HISTORIC AND DESIGN REVIEW COMMISSION

HDRC CASE NO: 2022-453
ADDRESS: 228 BARRERA
LEGAL DESCRIPTION: NCB 717 BLK 14 LOT 7
ZONING: IDZ, H
CITY COUNCIL DIST.: 1
DISTRICT: Lavaca Historic District
APPLICANT: NICHOLAS MELDE/Architexas
OWNER: JS&WS HOLDINGS LLC
TYPE OF WORK: Construction of a 2-story residential structure
APPLICATION RECEIVED: August 19, 2022
60-DAY REVIEW: Not applicable due to City Council Emergency Orders
CASE MANAGER: Rachel Rettaliata

REQUEST:

The applicant is requesting conceptual approval to construct a new 2-story, single-family residence totaling approximately 1,640 square feet with an attached carport.

**SITE PLAN**
SCALE: 1/4" = 1'-0"

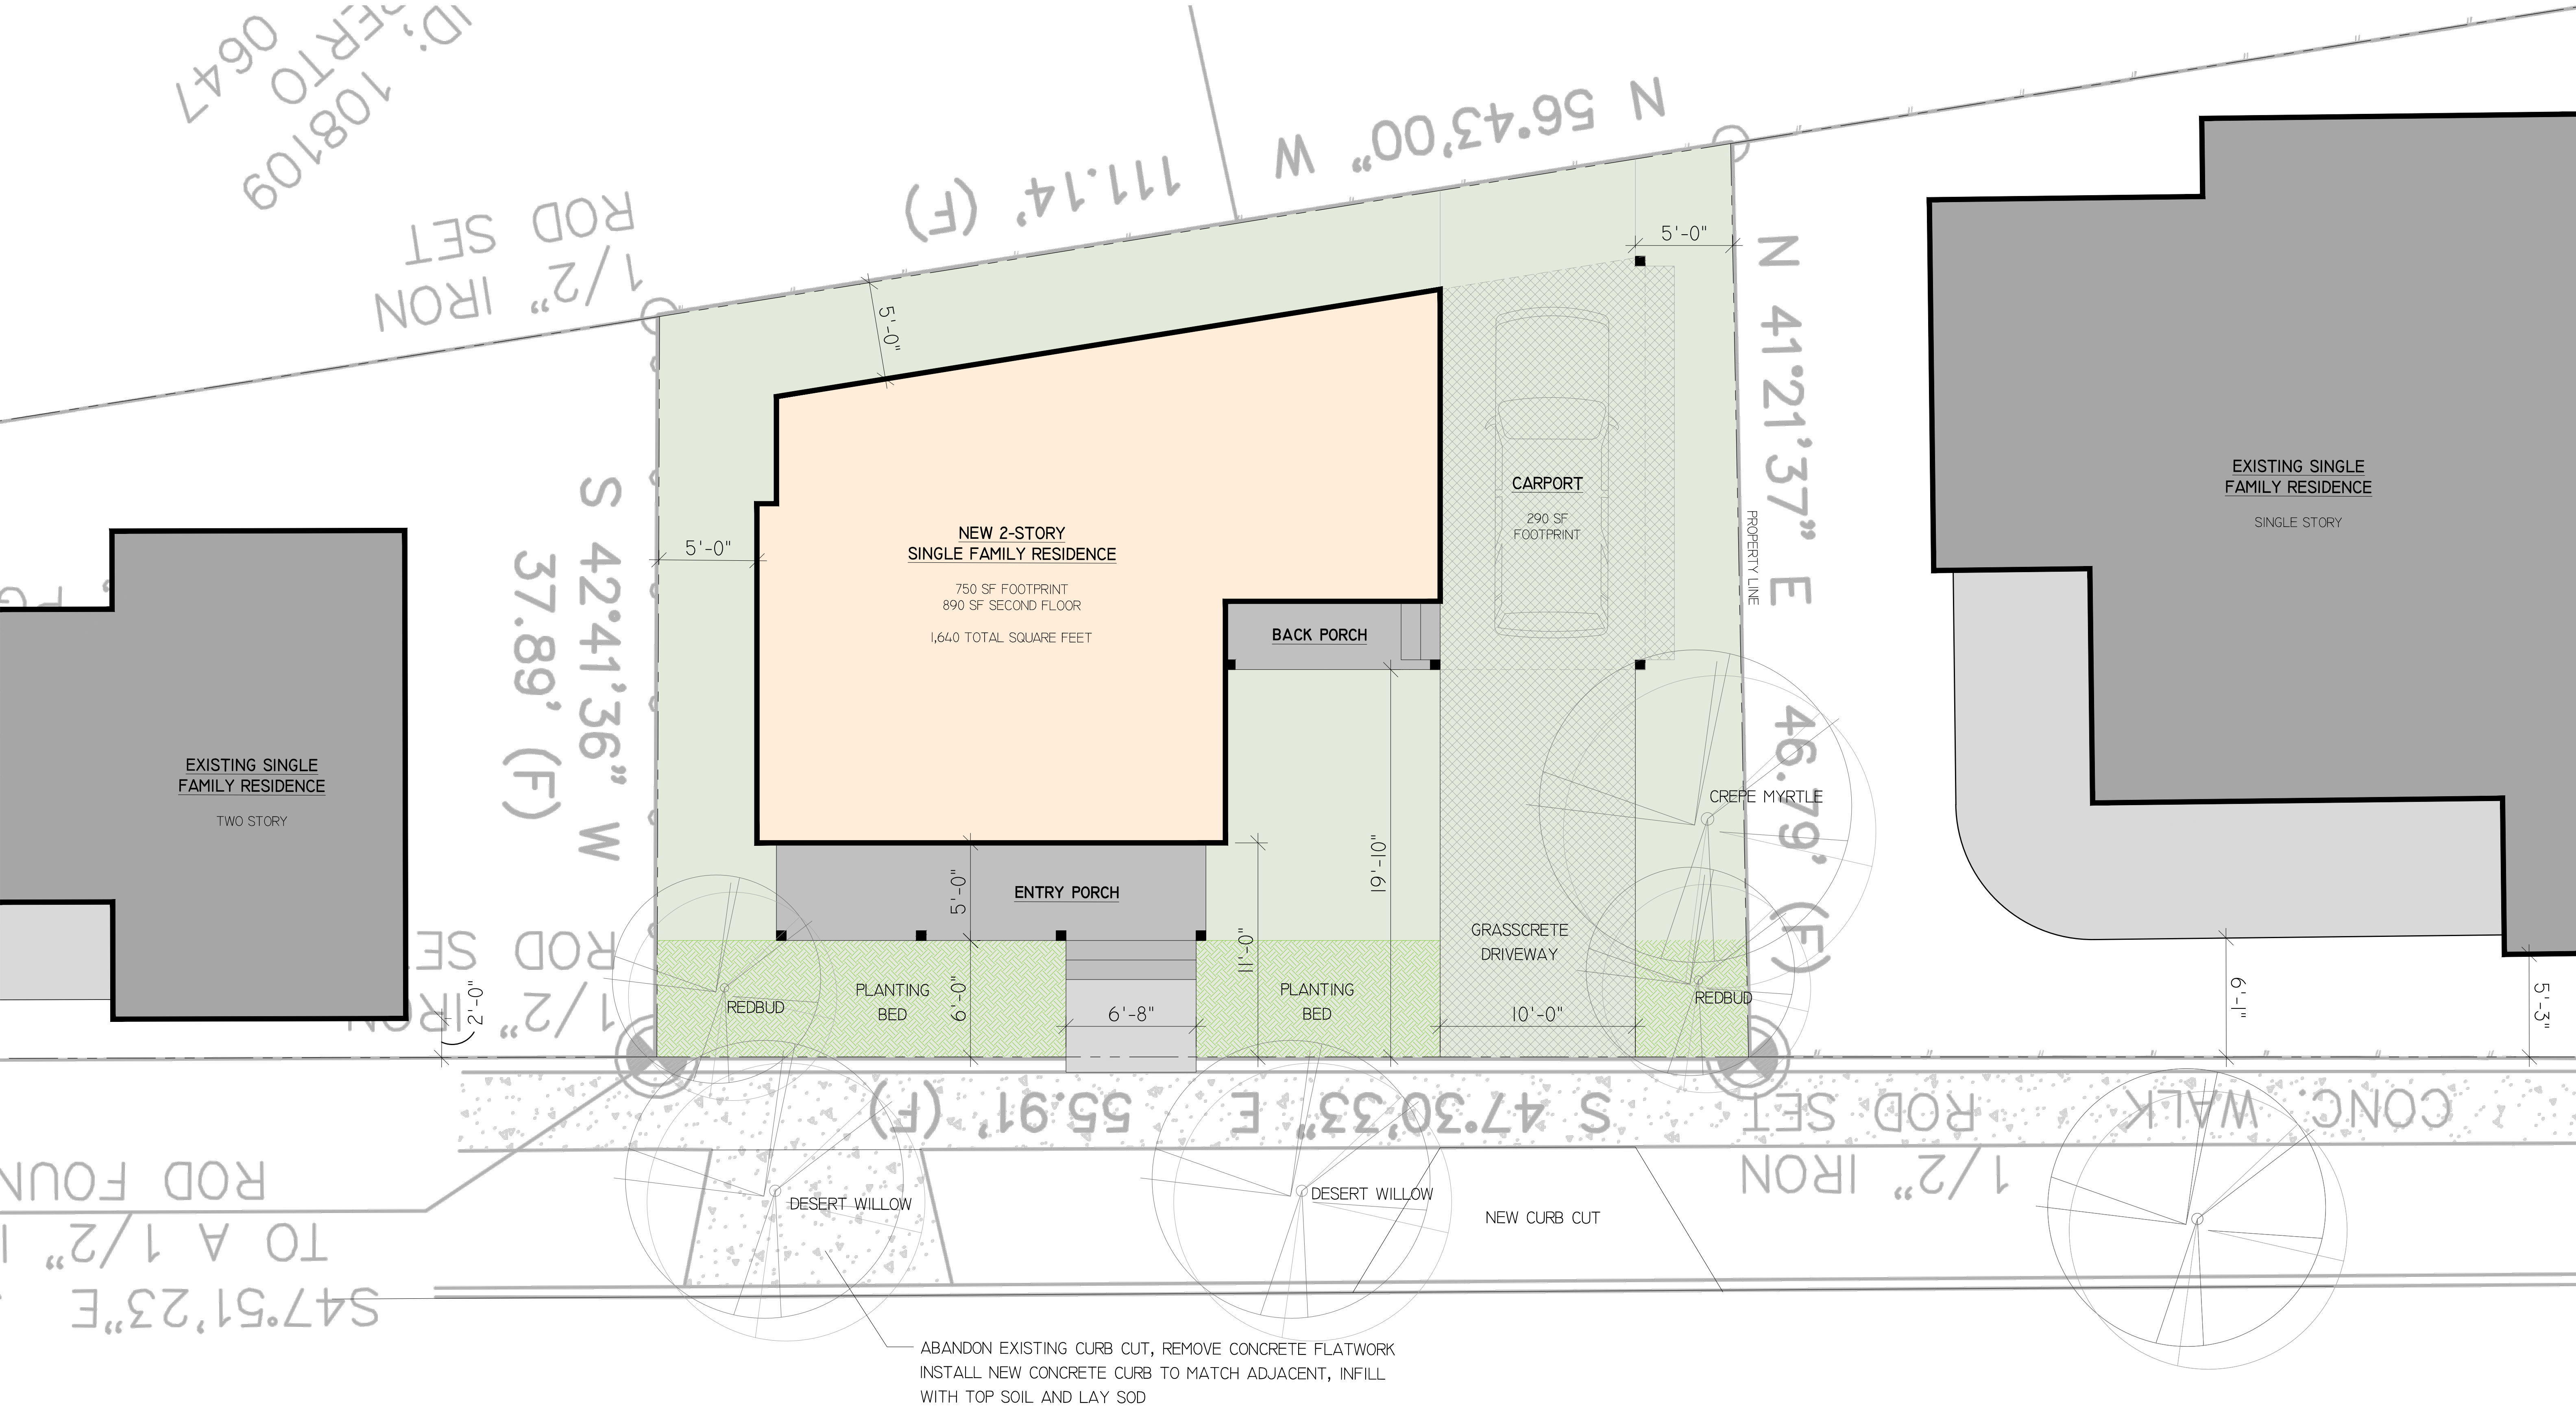
- d. SETBACK & ORIENTATION – According to the Guidelines for New Construction, the front facades of new buildings should align with the front facades of adjacent buildings where a consistent setback has been established along the street frontage. Additionally, the orientation of new construction should be consistent with the historic examples found on the block. The applicant has proposed to construct a 2-story, single family residence. The frontage of the residence will be oriented to the north and will face Barrera. The existing properties along Barrera are oriented toward Barrera. The applicant has proposed a front porch setback of 6' and the proposed setback for the carport volume is 19'-10". The proposed setbacks are behind the setbacks of the adjacent structures, which are set back 2' and 5'-3" from the property line. Staff finds the proposal consistent with the Guidelines.

- g. LOT COVERAGE – Guideline 2.D.i for New Construction stipulates that building to lot ratio for new construction should be consistent with adjacent historic buildings. Limit the building footprint for new construction to no more than 50 percent of the total lot area, unless adjacent historic buildings establish a precedent with a greater building to lot ratio. The applicant has provided a total square footage of 1,930 square feet including the second story. As the proposed second story is cantilevered, the square footage of the footprint is 750 square feet. The total square footage for the lot is 2,348 square feet and the total proposed lot coverage is less than 50 percent. Staff finds the proposal consistent with the Guidelines.

- m. DRIVEWAYS – Guideline 5.B.i for Site Elements notes that new driveways should be similar to those found historically within the district in regard to their materials, width, and design. Additionally, the Guidelines note that driveways should not exceed ten (10) feet in width. The property currently features concrete driveway aprons and curb cuts on the east and west ends of the property without a driveway. The applicant has proposed to install a 10-foot-wide Grasscrete driveway at the existing apron on the west side of the property and remove the secondary curb cut and driveway apron. Staff finds the proposal consistent with the Guidelines.

- n. SITE WORK – The Guidelines for Site Elements note that front yard walkways and site work should appear similar to those found historically within the district in regard to their materials, width, alignment and configuration. The applicant has proposed to install a 6’–8” wide, fully concrete front walkway from the existing sidewalk to the front porch, aligned with the interior of the front porch columns. Staff finds the proposal generally appropriate.

- p. LANDSCAPING PLAN – The applicant has proposed to install additional trees and a front planting bed. The property currently features front and rear fencing. The applicant has proposed to install a front driveway gate and to modify the front yard fence to feature a pedestrian gate. Adjacent properties currently feature front driveway gates. Staff finds that the applicant should submit a final landscaping plan with planting bed details and material specifications for the driveway and pedestrian gates prior to returning to the HDRC.

- ii. That the applicant submits a final landscaping plan with planting bed details and material specifications for the driveway and pedestrian gates prior to returning to the HDRC as noted in finding p.
